PŘÍKAZ K ZACHOVÁNÍ LETOVÉ ZPŮSOBILOSTI

Číslo: DCA/750XL/13

- DCA/750XL/13** **Aileron Inboard Hinge Attachment – Inspection and Modification**
- Applicability:** Model PAC 750XL aircraft, S/N 101, 102, 104 through to 120, and 122 through to 129, except aircraft with modification PAC/XL/0285 already embodied.
- Requirement:** To prevent cracks developing in the aileron spar adjacent to the inboard hinge attachment accomplish the following:
- Remove both ailerons, inspect and modify the aileron spar at the inboard hinge attachment point in accordance with Pacific Aerospace Ltd Service Bulletin PACSB/XL/027.
- Note:** Aileron removal, installation and rigging procedures are detailed in PAC 750XL Maintenance Manual Chapter 27-10-00.
- Compliance:** Within the next 150 hours TIS or six months, whichever occurs sooner.
- Effective Date:** 26 April 2007

REPAIR / STIFFENING AILERON INBOARD HINGE ATTACHMENT

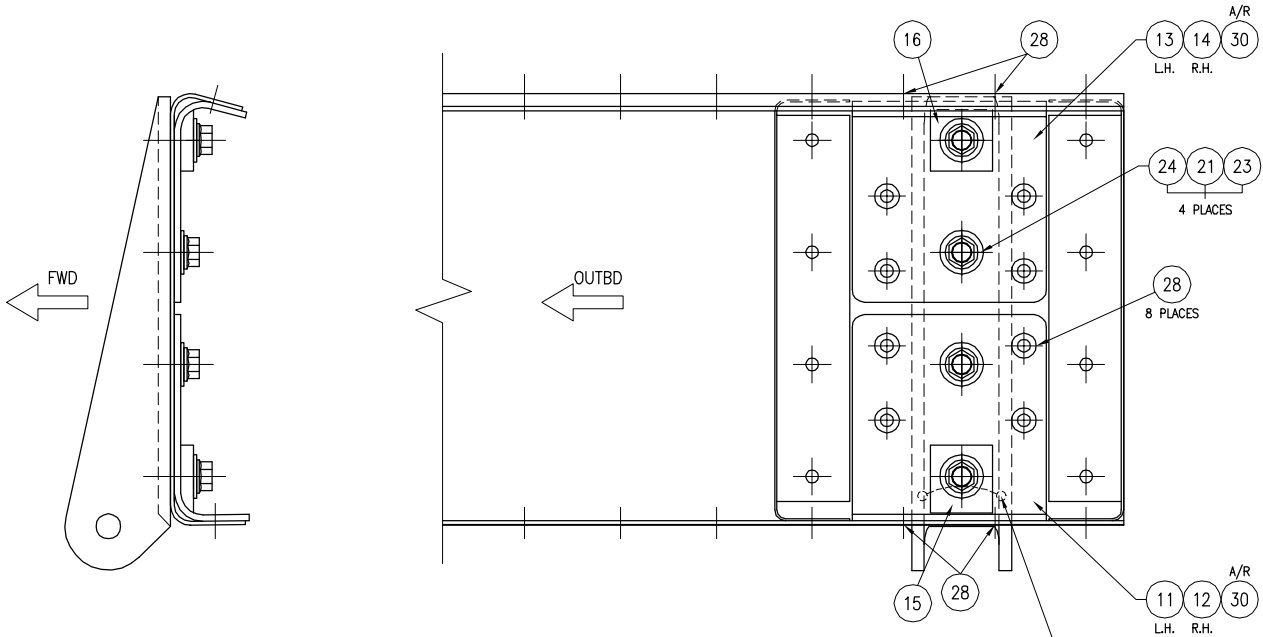
| B. | REASON | To prevent / repair cracking of the aileron spar at the inboard hinge attachment point. |
| C. | DESCRIPTION | Two cases were reported where the aileron spar started cracking at the inboard hinge attachment point. |

- i) Remove the ailerons i a w the MM Chapter 27-10-00, Pg 409, Par 15.
- ii) Rework the ailerons i a w drawing 11-03141/42.
- iii) Reinstall the ailerons i a w MM Chapter 27-10-00, Pg 409, Par 16.
